<b>Title - Sujet</b> Modernisation des systèmes d'alarme	
<b>Solicitation No. - N° de l'invitation</b> EW038-191179/A	<b>Amendment No. - N° modif.</b> 001
<b>Client Reference No. - N° de référence du client</b> NRCan	<b>Date</b> 2018-08-31
<b>GETS Reference No. - N° de référence de SEAG</b> PW-\$PWU-004-11428	
<b>File No. - N° de dossier</b> PWU-8-41094 (004)	<b>CCC No./N° CCC - FMS No./N° VME</b>
<b>Solicitation Closes - L'invitation prend fin</b> <b>at - à 02:00 PM</b> <b>on - le 2018-09-10</b>	<b>Time Zone</b> <b>Fuseau horaire</b> Mountain Daylight Saving Time MDT
<b>F.O.B. - F.A.B.</b> <b>Plant-Usine:</b> <input type="checkbox"/> <b>Destination:</b> <input type="checkbox"/> <b>Other-Autre:</b> <input type="checkbox"/>	
<b>Address Enquiries to: - Adresser toutes questions à:</b> Espedido, Karieleen K.	<b>Buyer Id - Id de l'acheteur</b> pwu004
<b>Telephone No. - N° de téléphone</b> (780) 497-3859 ( )	<b>FAX No. - N° de FAX</b> (780) 497-3510

**N°001 DE LA MODIF**

Project: NRCan Fire Alarm Replacement and  
Emergency Lighting Upgrade

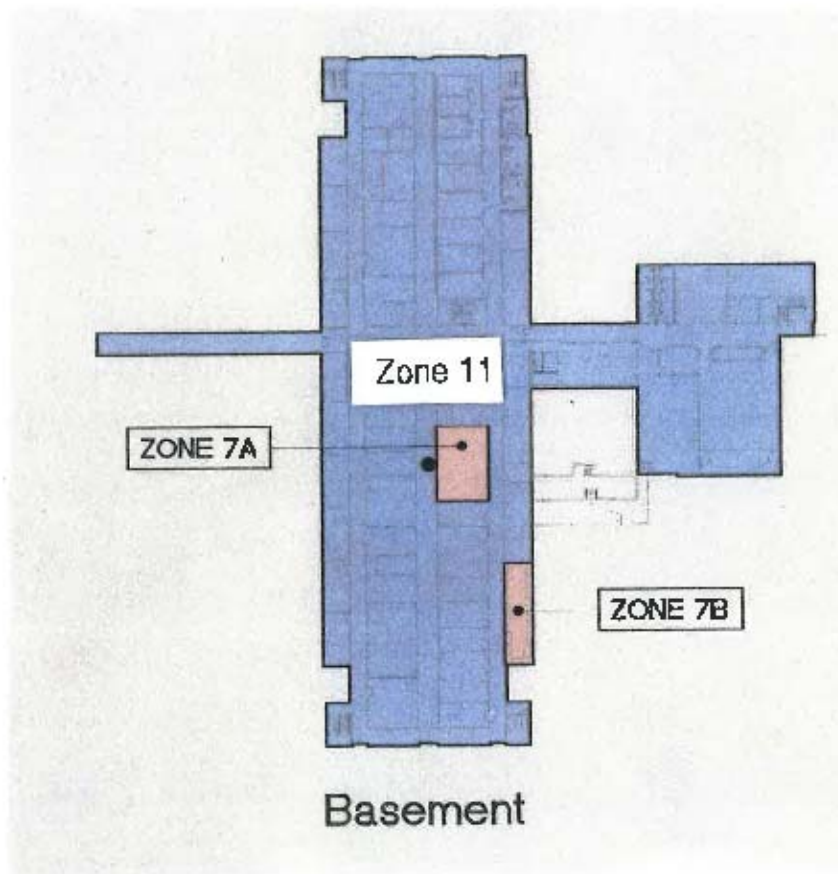
15. On the tender documents for Northern Forestry fire alarm and emergency lighting upgrade. "Note 2" on prints E101 – E105 state that the exit signs are to be replaced with new running man exit signs. The Engineer has placed a note 2 symbol beside most of the exit signs, but not all. Can you please confirm if this is just a mistake or they truly do not want all the exit signs without the note 2 replaced? For example print E-102 has an exit sign shown above the 4 doorways leading from the central office hallways but only one of them has a note 2 symbol beside it.

The intent is that all exit signs shown on the drawings are to be replace with new exit "running man" exit signs regardless if the have keynote 2 beside them.

Fire Alarm Zone Schedule:

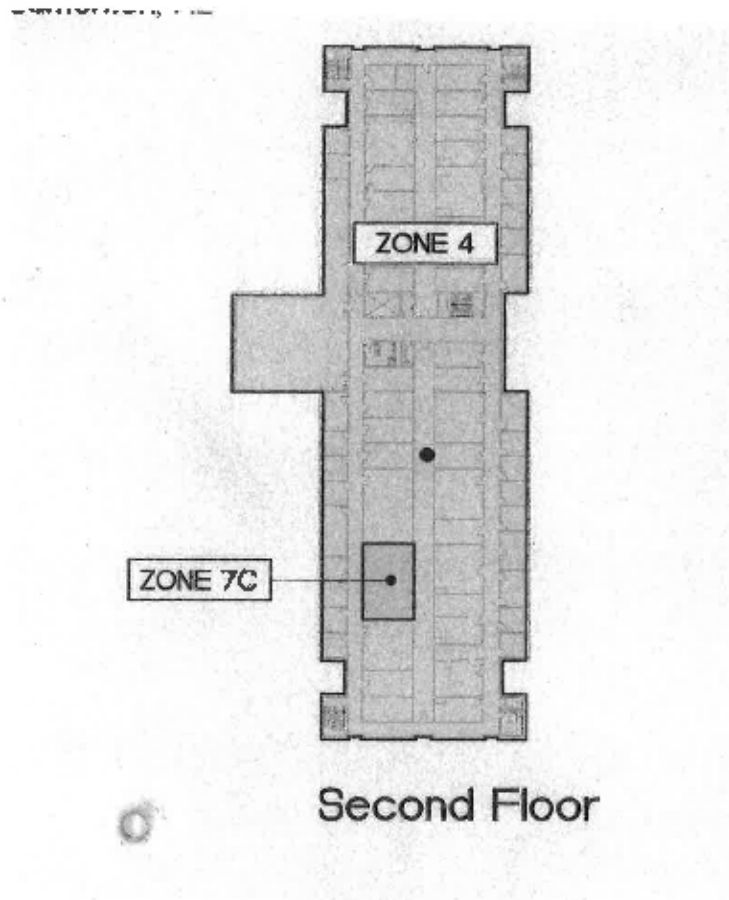
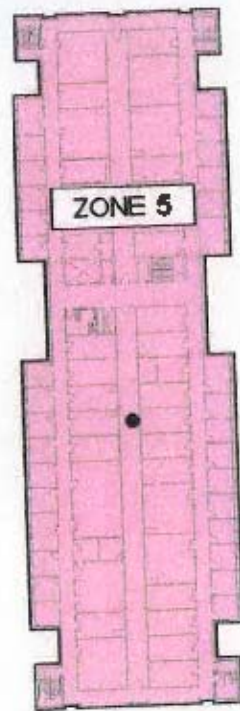
16. Existing fire alarm panel is a Cerberus Pyrotronics Model: MXL and it is an addressable fire alarm Panel.
17. Existing fire alarm zones are as follows:

Zone	Location
Zone 11	Basement
Zone 12	First Floor
Zone 3	First Floor West
Zone 4	Second Floor
Zone 5	Third Floor

Zone 6	Penthouse
Zone 7A	Clean Agent System B089
Zone 7B	Clean Agent System 2052/2053
Zone 8A	Anti-Freeze System Loading Dock
Zone 8B	Anti-Freeze System Cold Storage
Zone 29	Pig Barn
Zone 30	Pig Barn

Third Floor

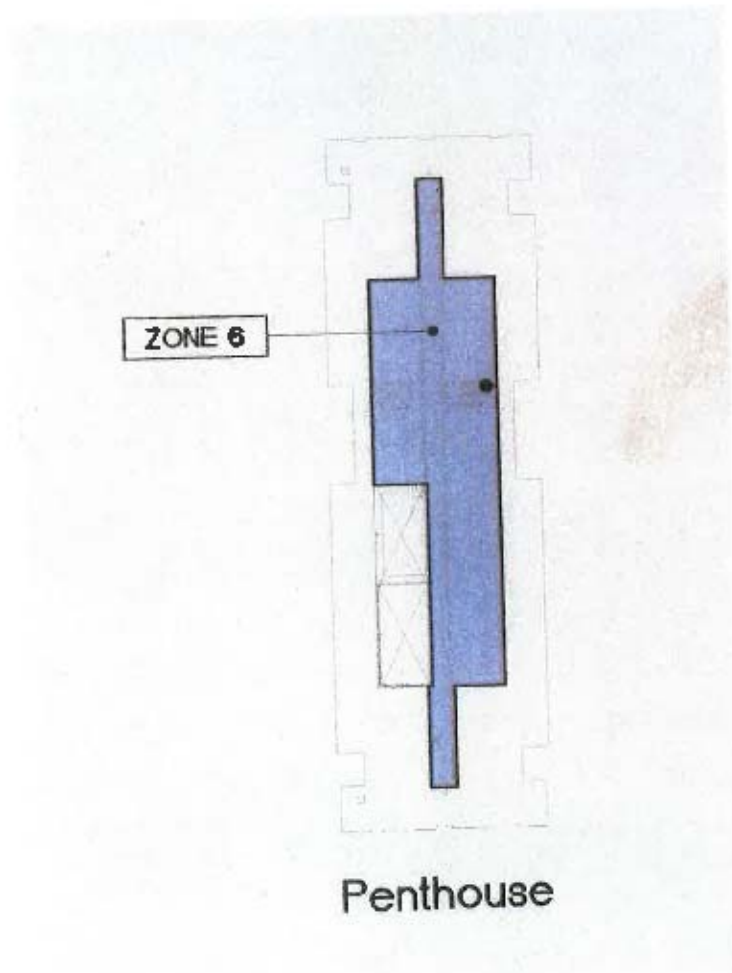
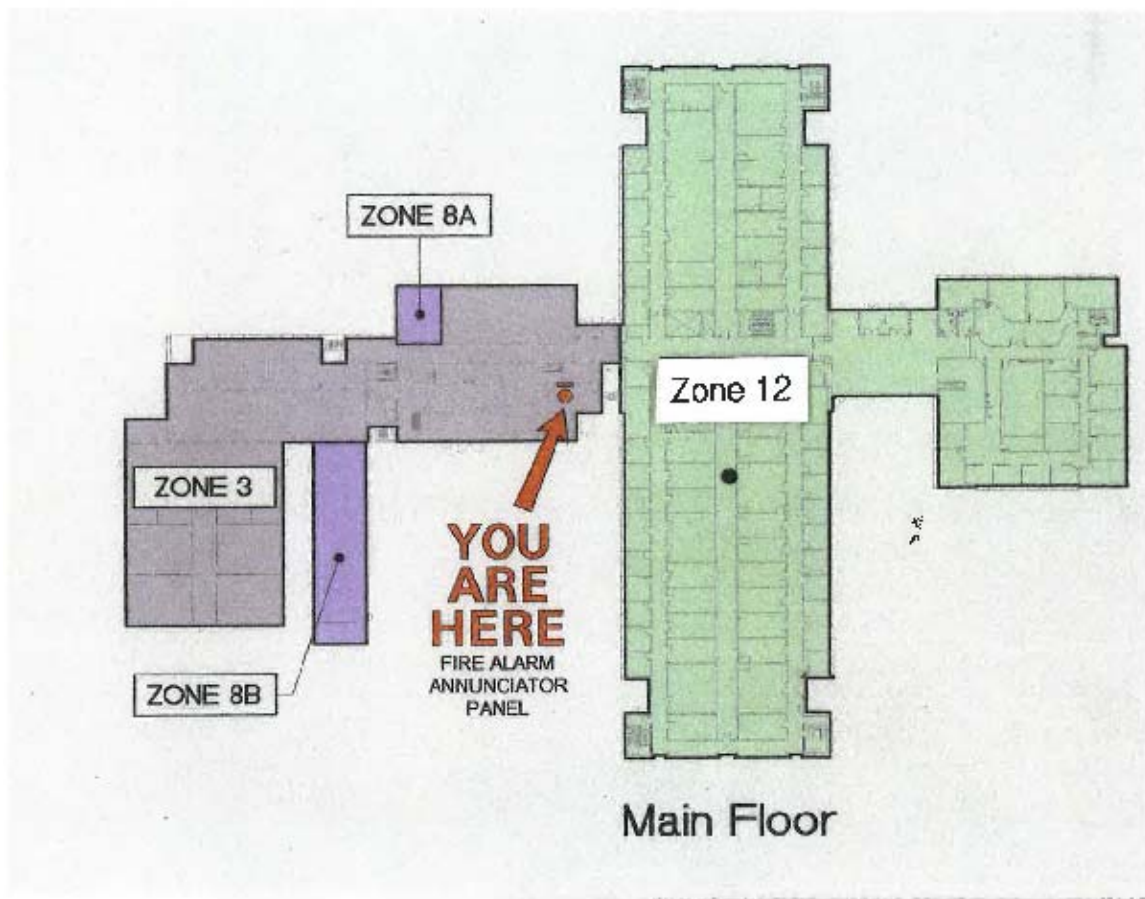
18. Fire Alarm Zones as follows:
